## SUBMITTAL TRANSMITTAL

**Submittal #: 16231-001.A**

PROJECT: **Harold Thompson Regional WRF**  
Birdsall Rd.  
Fountain, CO 80817  
Job No. 2908

SUBJECT: Resubmittal - Response to April 9<sup>th</sup> Review of the Packaged Engine  
Generators: 600 kW & 1250 kW GenSets w/ 800 Amp & 2000 Amp ATS's

TITLE: INTERCONNECT PCC2100  
 NETWORK&Z-NET ANNUNCIATOR  
 SIZE DWG NO: 5000537 REV: A  
 SCALE: NONE DO NOT SCALE SHEET: 1 OF 1

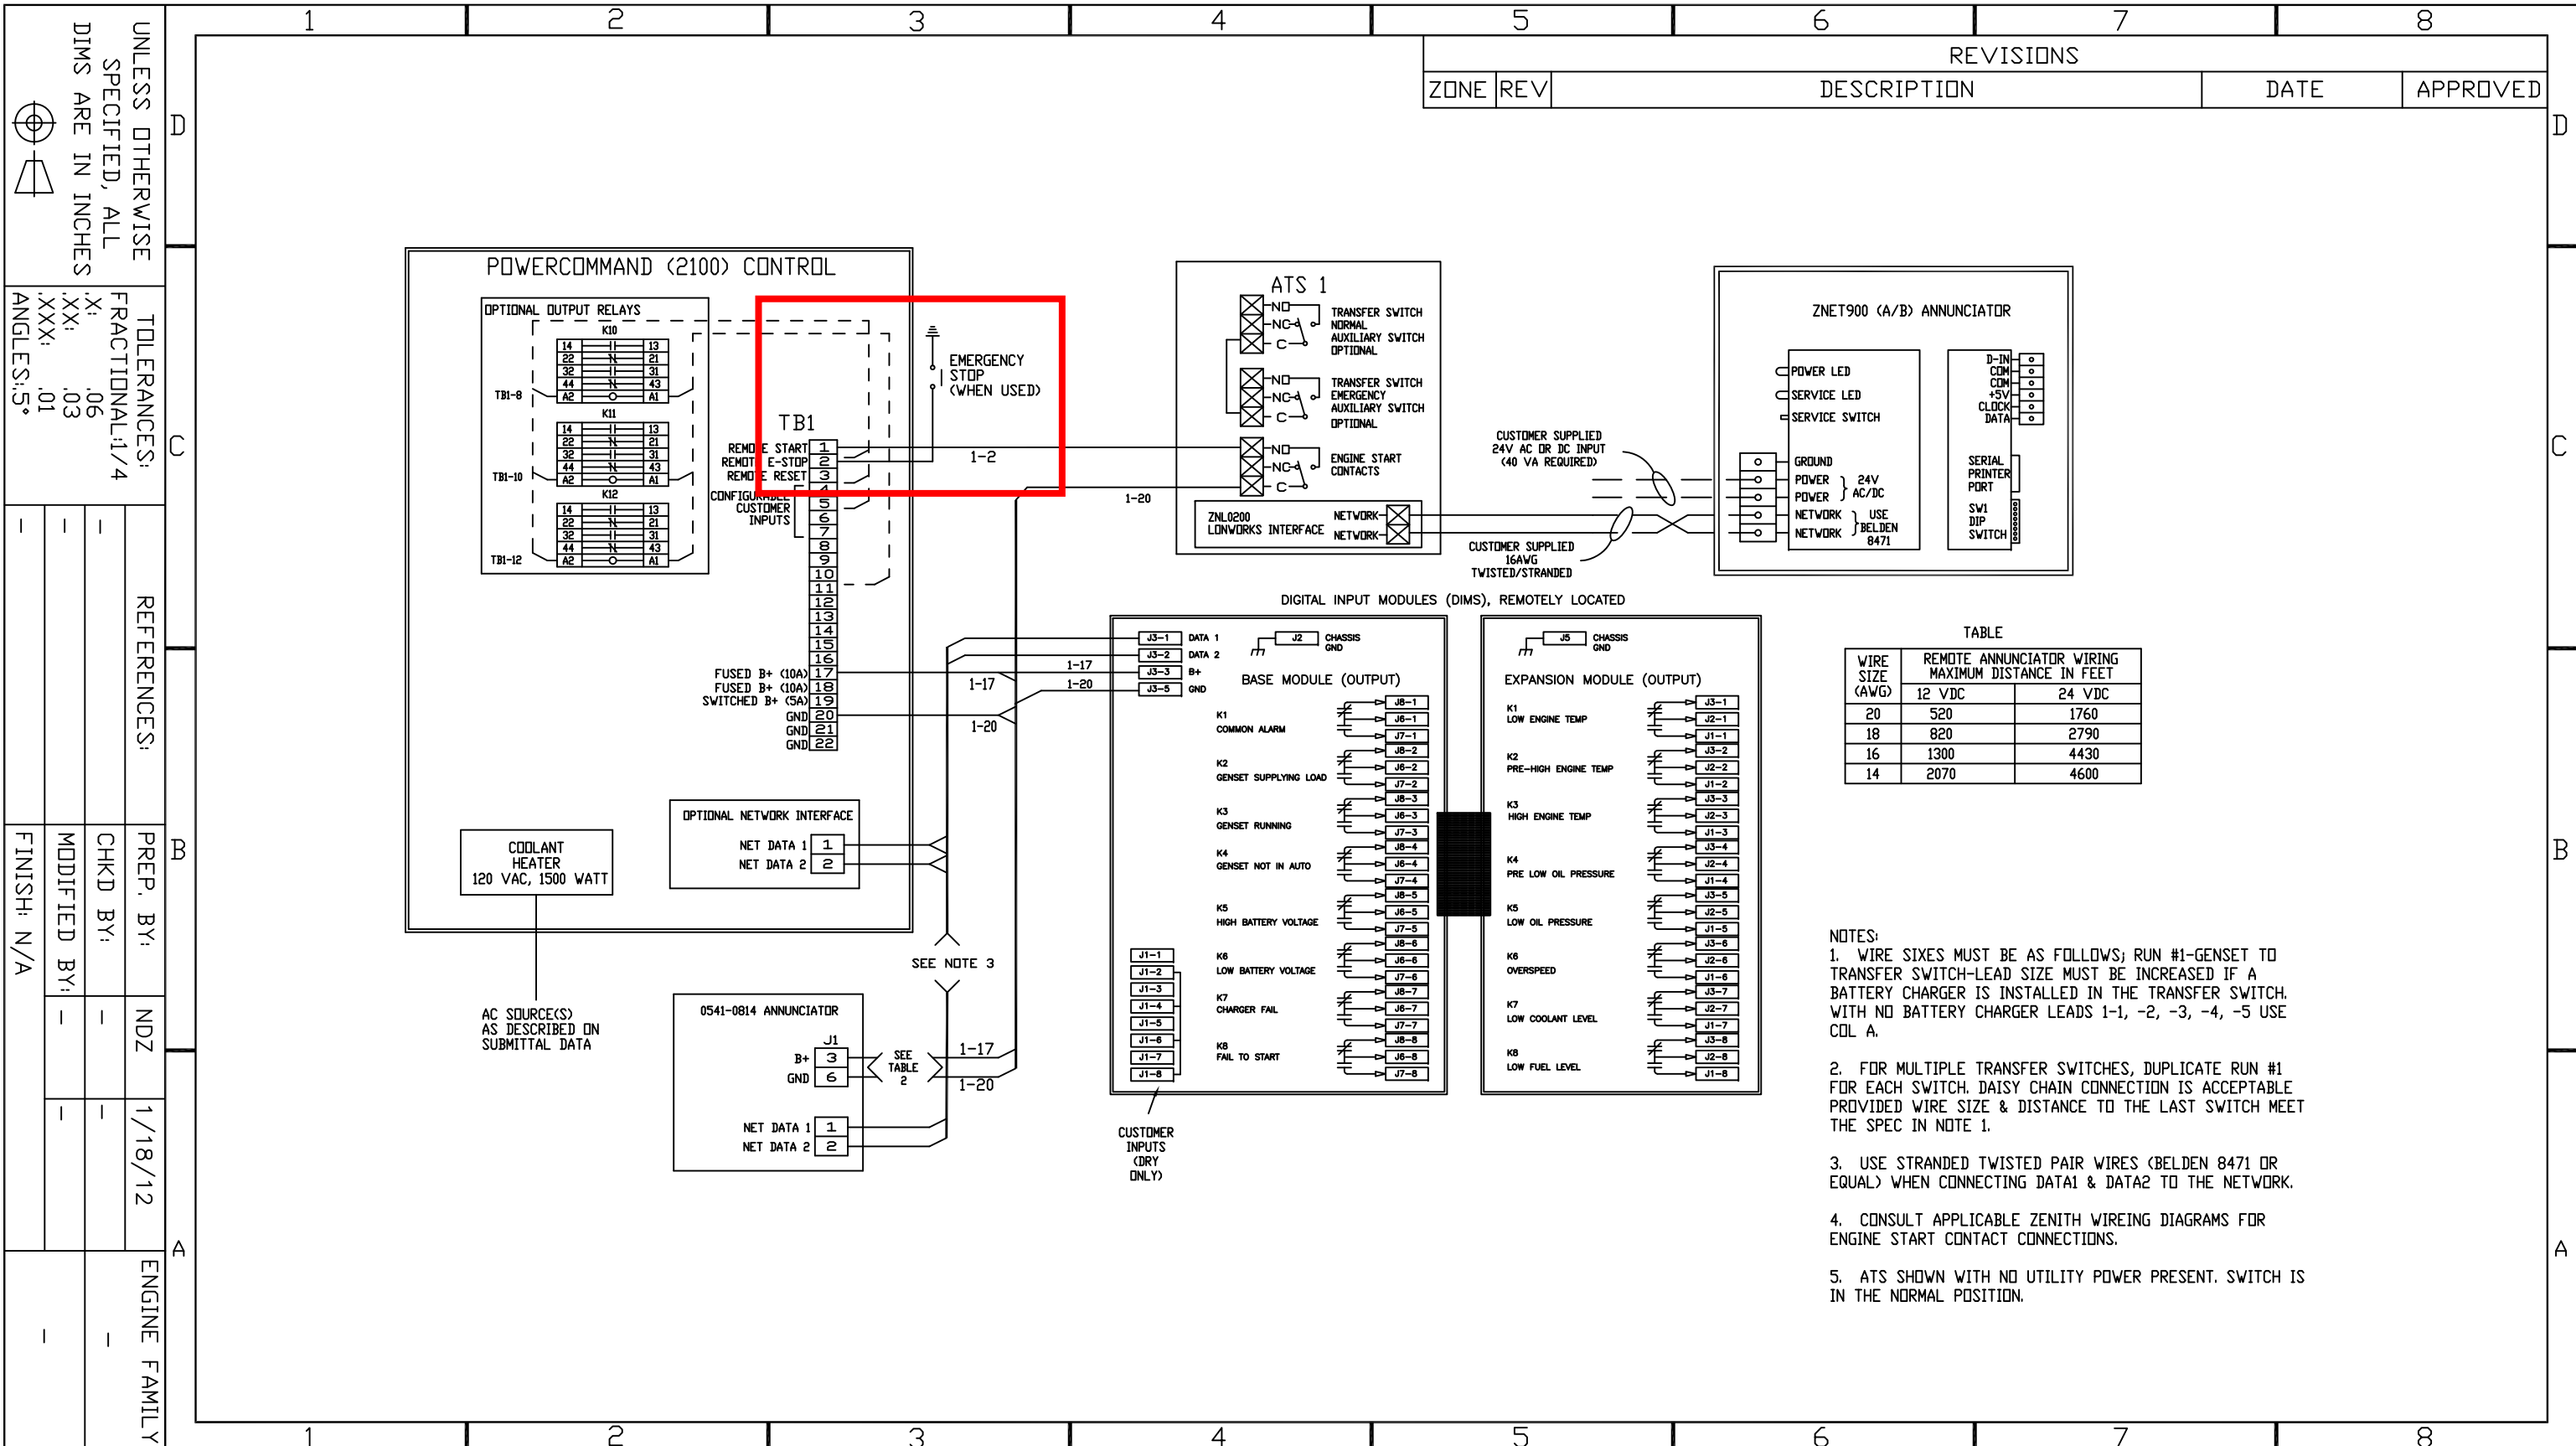
- 1.) “Provide emergency stop switch for generator and locate adjacent to generator remote annunciator.”

*Cummins Response: A flush mount emergency stop switch will ship loose to be installed by the contractor with the remote annunciator. This will require 2 wires to be ran from the emergency stop switch to the generator.*

TITLE: ELECTRICAL STUB-UP  
 SIZE: B  
 DWG NO: P2011-0140A  
 SCALE: 1:30  
 DO NOT SCALE  
 SHEET: 4 OF 4  
 REV: B

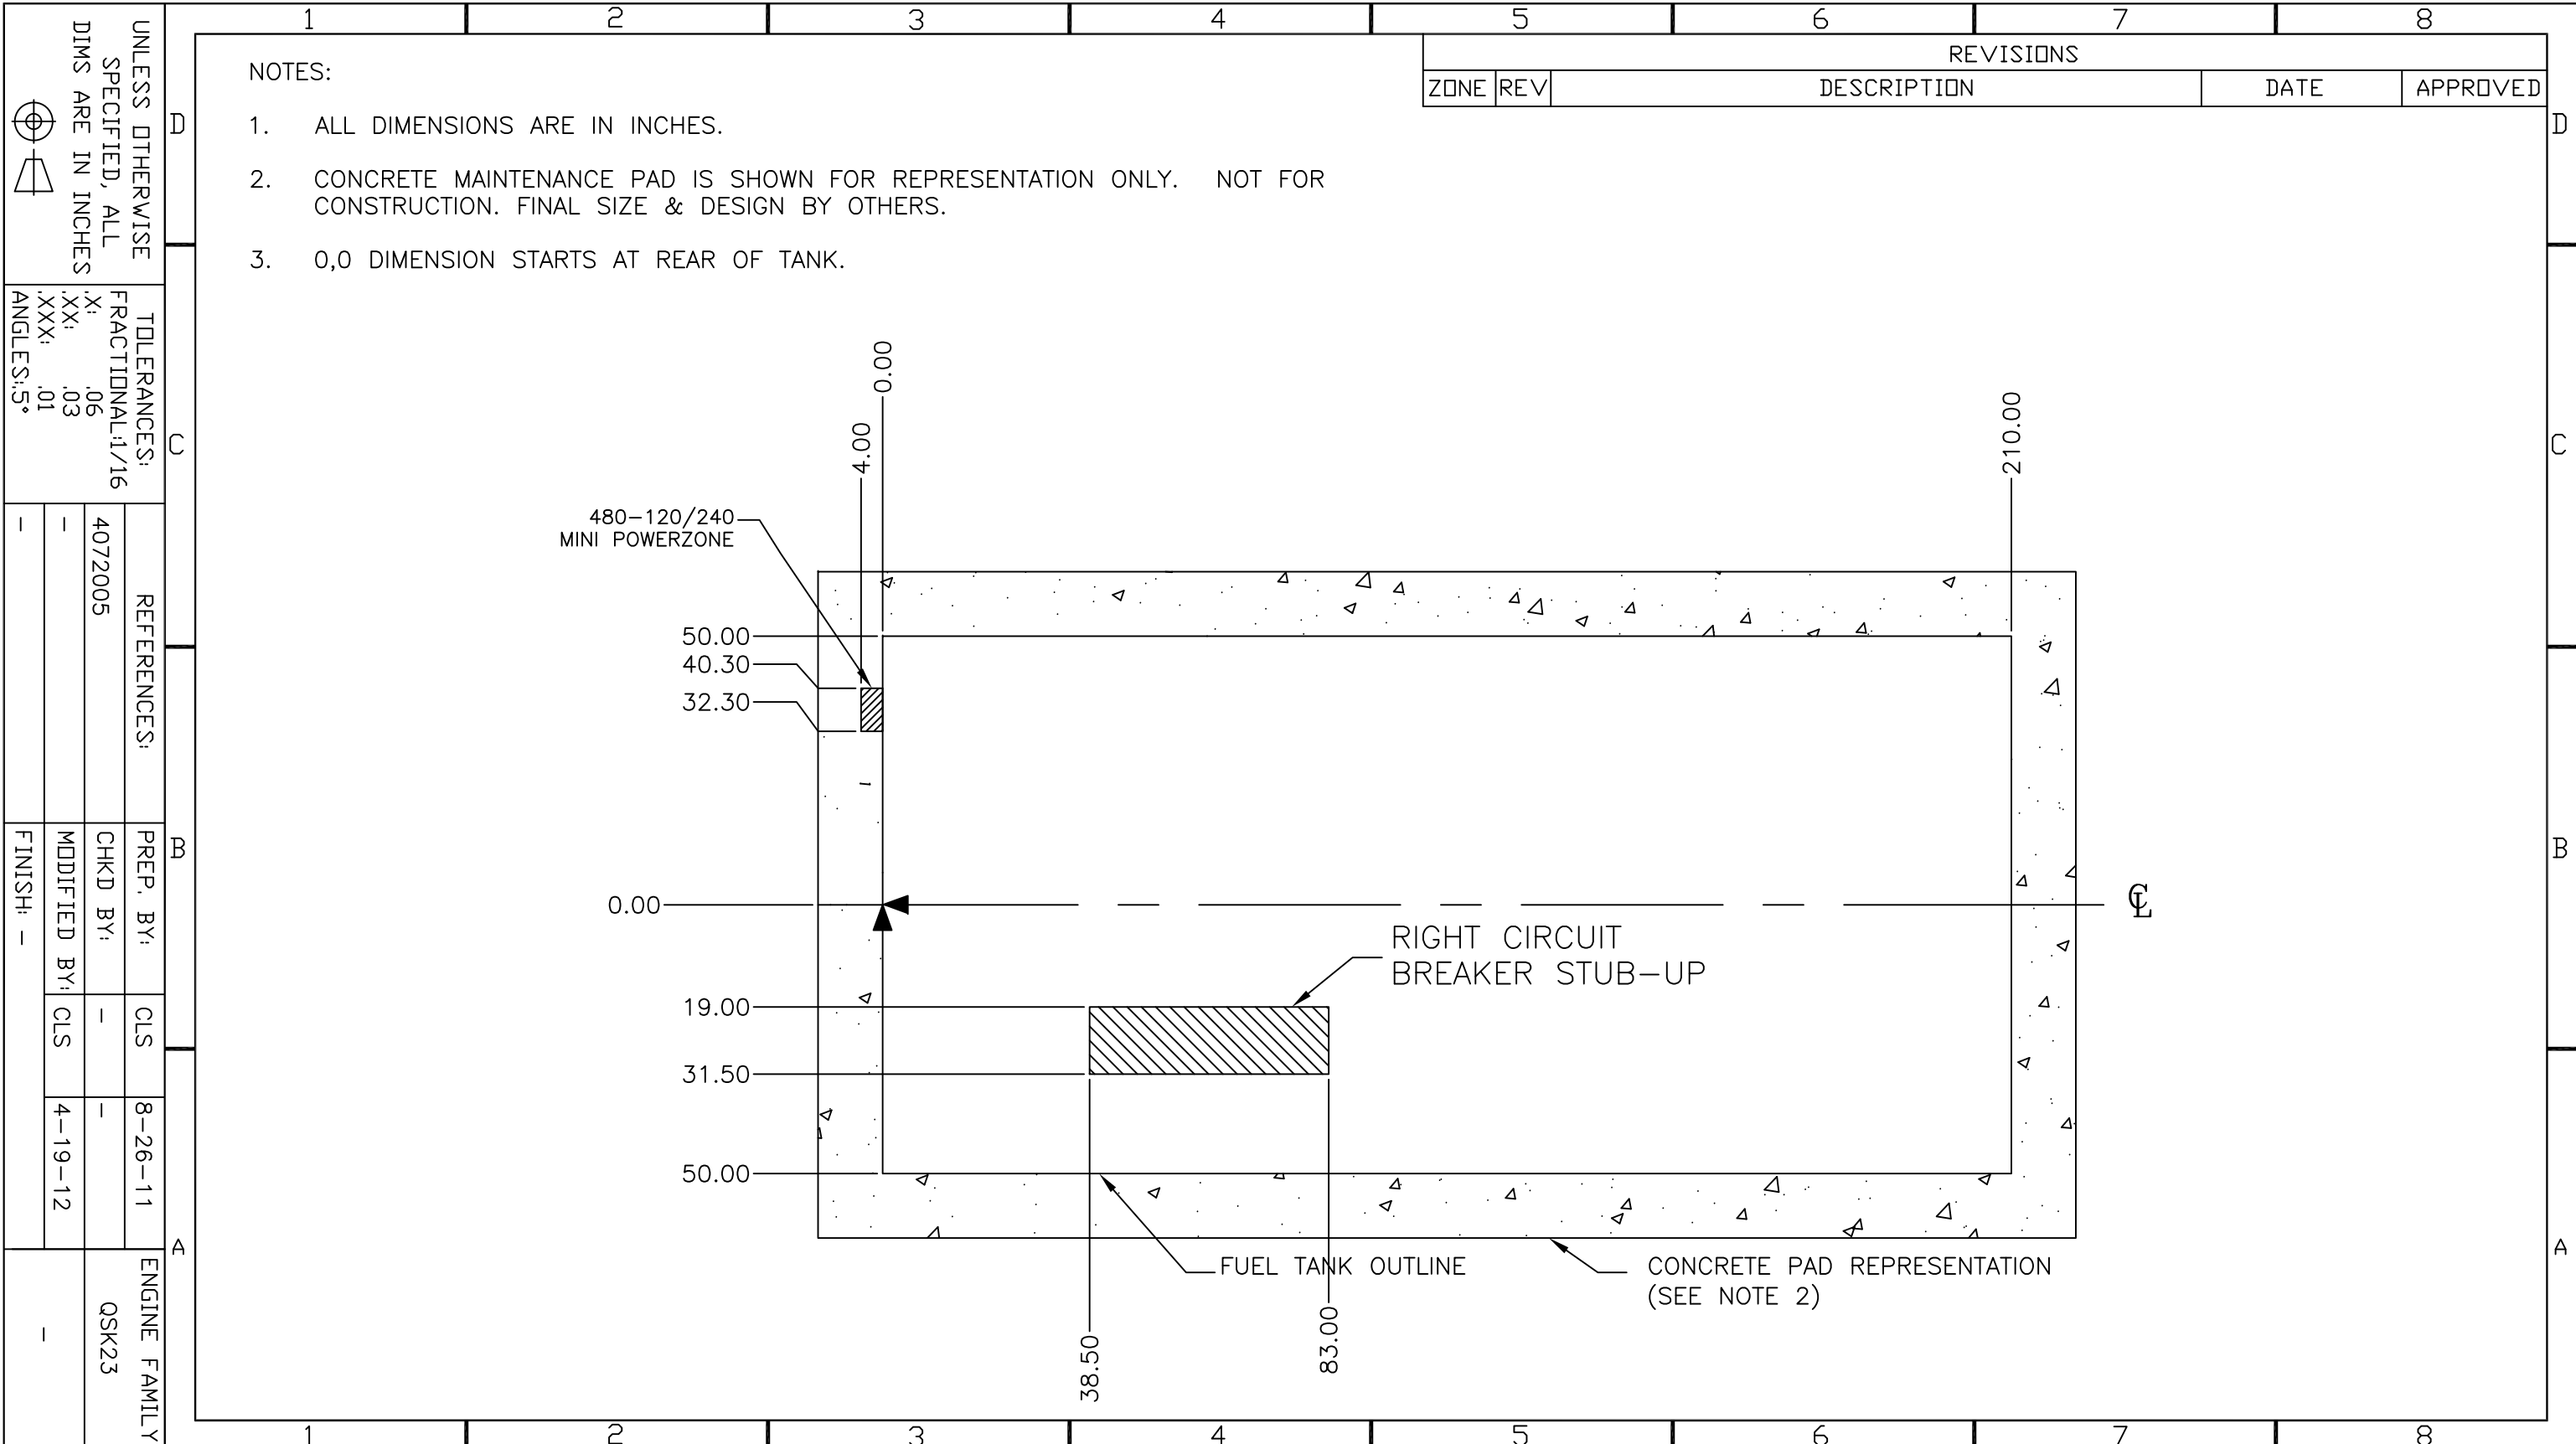
- c.) “Generator Layout: Drawings indicate generator main breaker to be located left side of generator (South side on plan). Change main breaker location to right side (North side, facing PD building). Fuel fill location as shown on South side facing road is correct.”

*Cummins Response: The circuit breaker will be located on the right side of the control.*

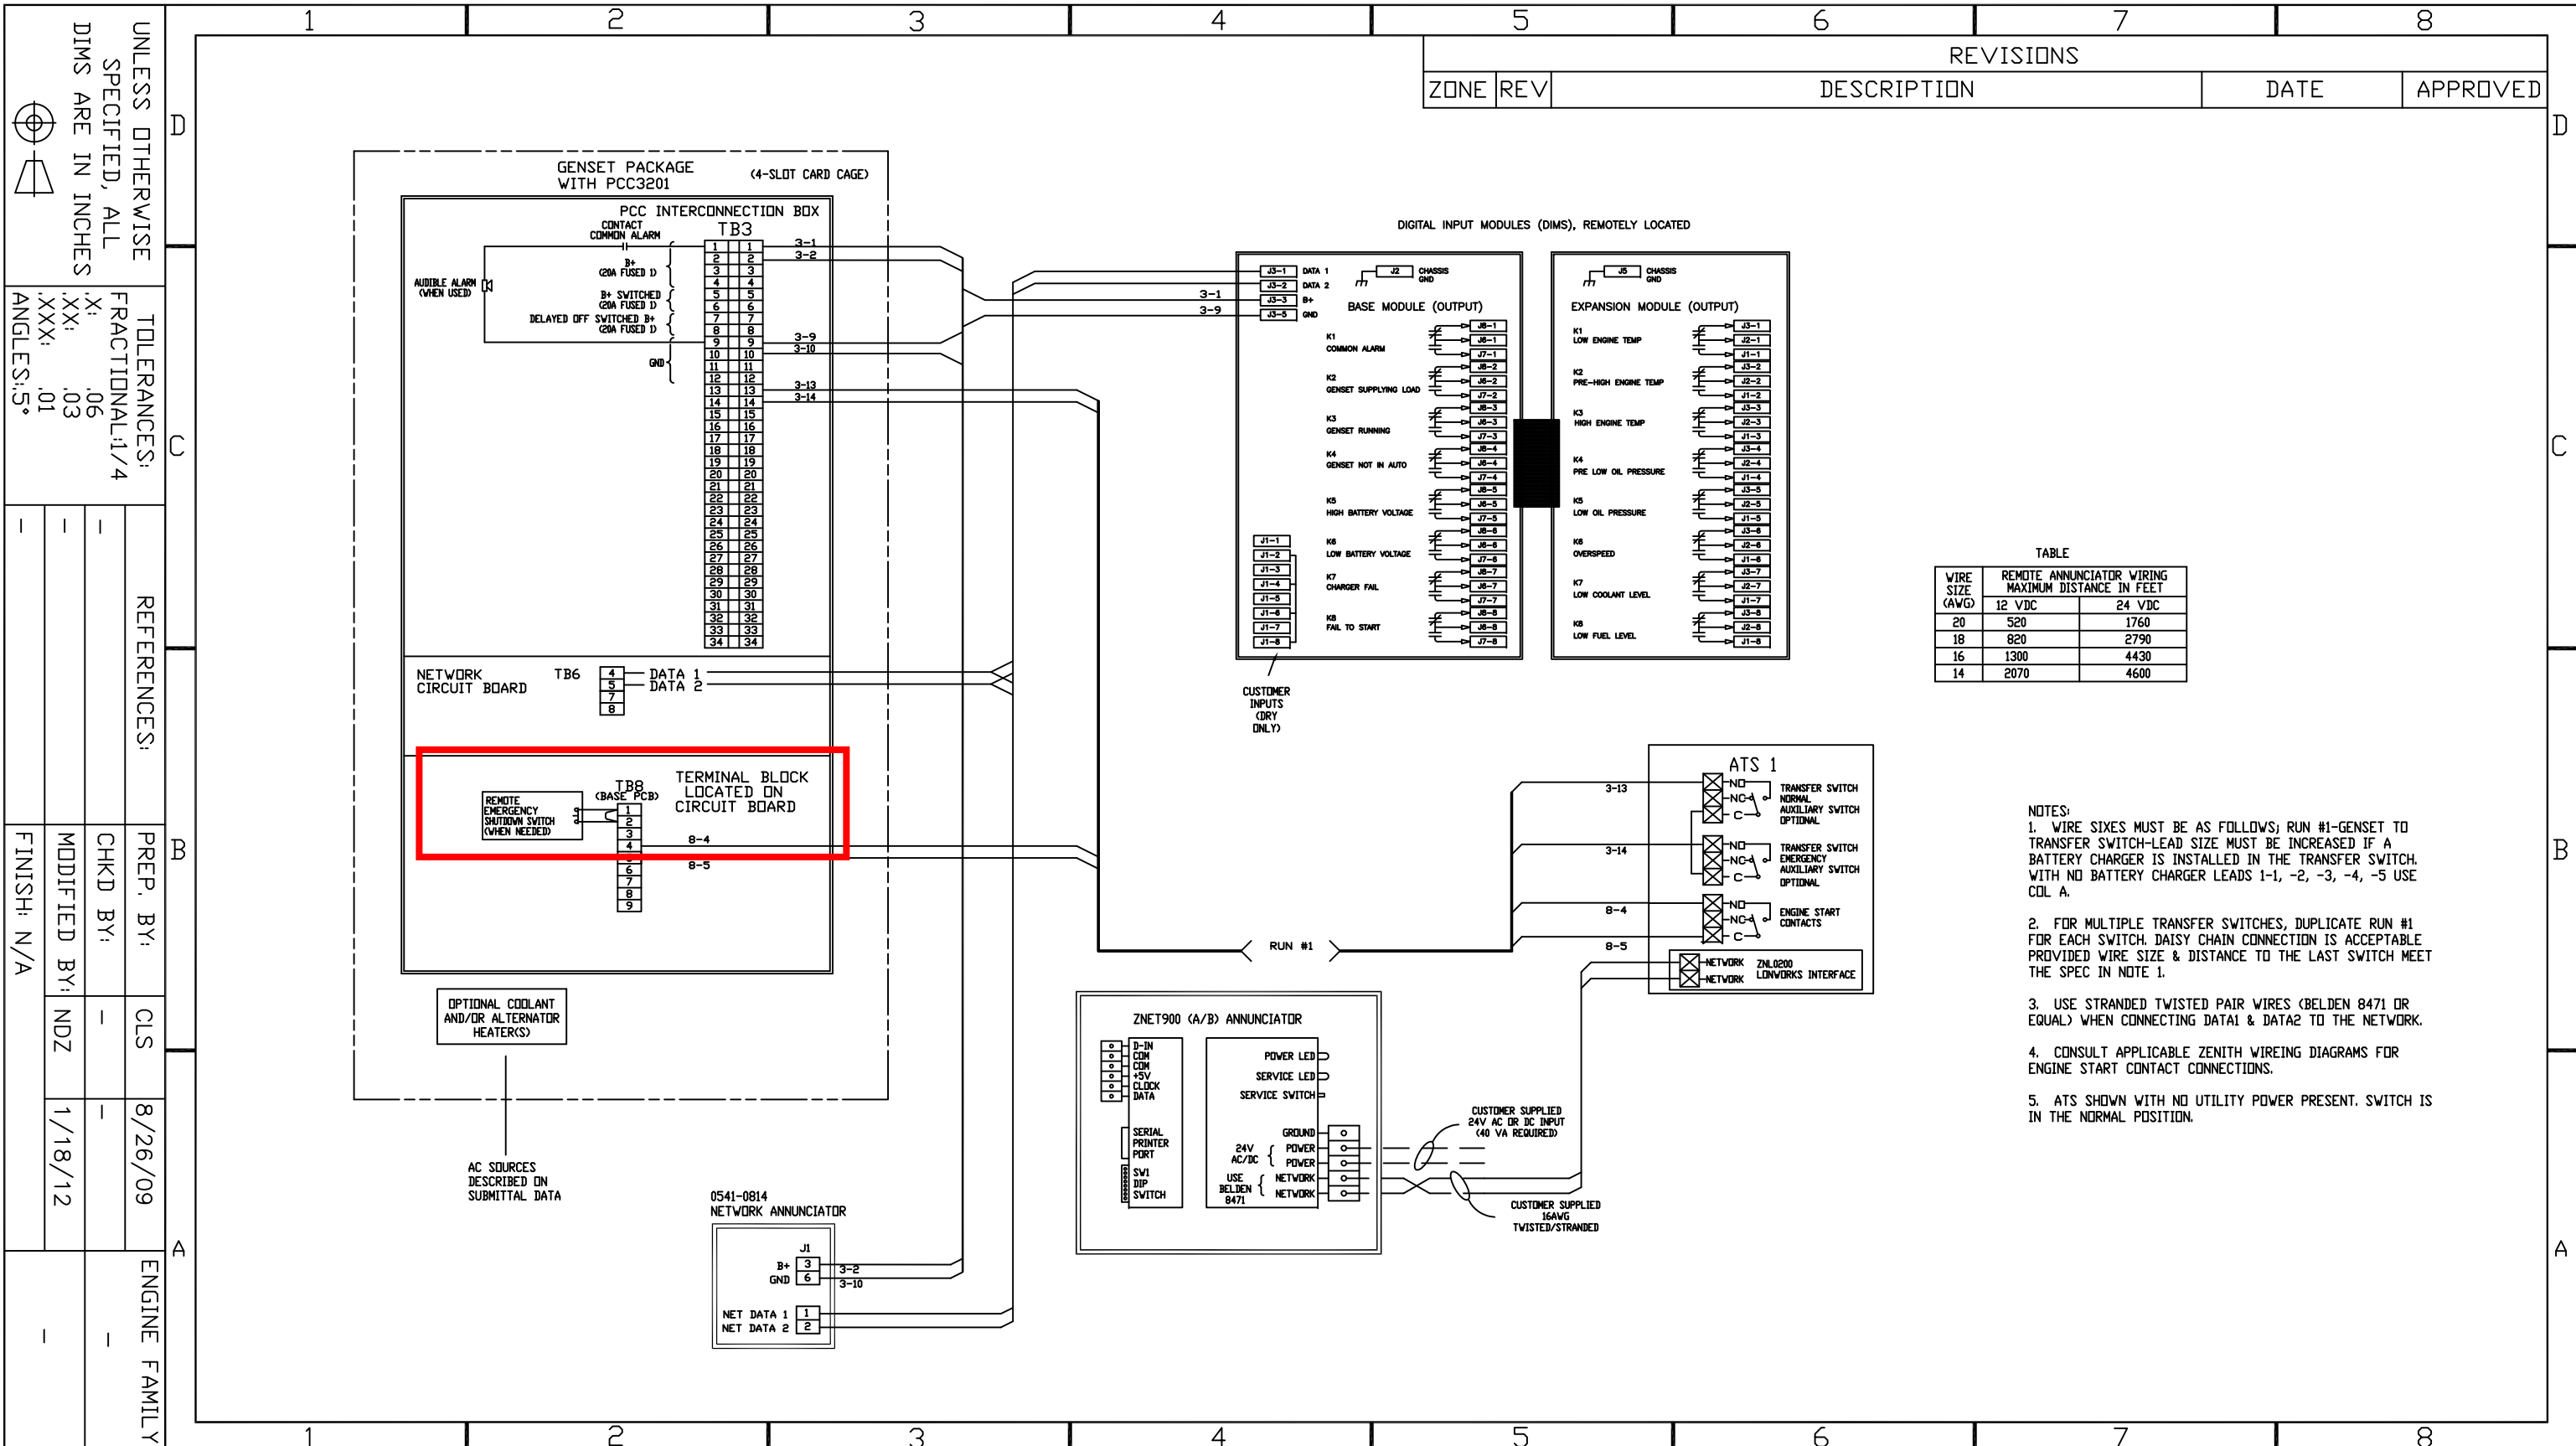
- 1.) “Provide emergency stop switch for generator and locate adjacent to generator remote annunciator as noted on drawing EEM-2.”

*Cummins Response: An flush mount emergency stop switch will ship loose to be installed by the contractor with the remote annunciator. This will require 2 wires to be ran from the emergency stop switch to the generator.*
